STATE OF NORTH CAROLINA
DEPARTMENT OF TRANSPORTATION

CONTRACT: DB00604
TIP NUMBER: BP2.R021
WBS ELEMENT: BP2.R021.3
COUNTY: JONES
ROUTE: SR 1155
DESCRIPTION: REPLACEMENT OF BRIDGE 72 ON SR 1155 IN JONES
COUNTY

ADDENDUM 2

DETAIL OF MILLING AT PAVEMENT TIE-INS

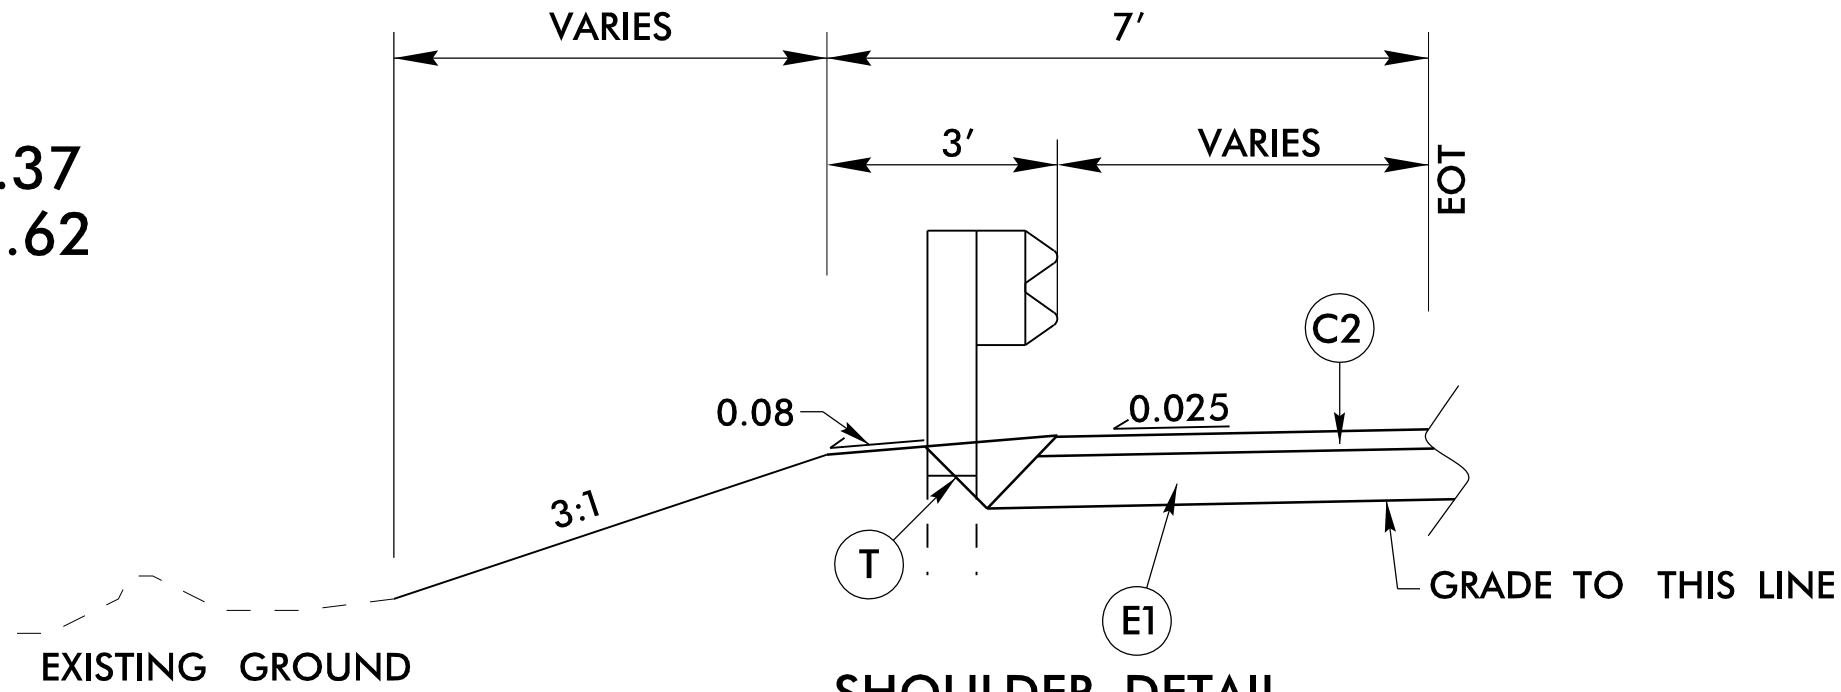
- Addition of Line Item 0073 MILLING ASHPHALT PAVEMENT, 0" TO 1.5"
- Pavement Schedule revised "V" to Milling, 0" -1.5" on Plan Page 2A-1.
- A revised electronic file has been uploaded to bid express named DB00604.001.

PAVEMENT SCHEDULE	
C1	PROP. APPROX. 1.5" ASPHALT CONCRETE SURFACE COURSE, TYPE S9.5B, AT AN AVERAGE RATE OF 165 LBS. PER SQ. YD.
C2	PROP. APPROX. 3" ASPHALT CONCRETE SURFACE COURSE, TYPE S9.5B, AT AN AVERAGE RATE OF 165 LBS. PER SQ. YD. IN EACH OF TWO LAYERS.
C3	PROP. VAR. DEPTH ASPHALT CONCRETE SURFACE COURSE, TYPE S9.5B, AT AN AVERAGE RATE OF 110 LBS. PER SQ. YD. PER 1" DEPTH. TO BE PLACED IN LAYERS NOT LESS THAN 1" IN DEPTH OR GREATER THAN 1.5" IN DEPTH.
E1	PROP. APPROX. 5" ASPHALT CONCRETE BASE COURSE, TYPE B25.0C, AT AN AVERAGE RATE OF 570 LBS. PER SQ. YD.
E3	PROP. VAR. DEPTH ASPHALT CONCRETE BASE COURSE, TYPE B25.0C, AT AN AVERAGE RATE OF 114 LBS. PER SQ. YD. PER 1" DEPTH, TO BE PLACED IN LAYERS NOT GREATER THAN 5 1/2" IN DEPTH OR LESS THAN 3" IN DEPTH
R1	SHOULDER BERM GUTTER
T	EARTH MATERIAL
U	EXISTING PAVEMENT
V	MILLING, 0"-1.5" (SEE MILLING DETAIL THIS SHEET)
W	VARIABLE DEPTH ASPHALT PAVEMENT (SEE WEDGING DETAIL)
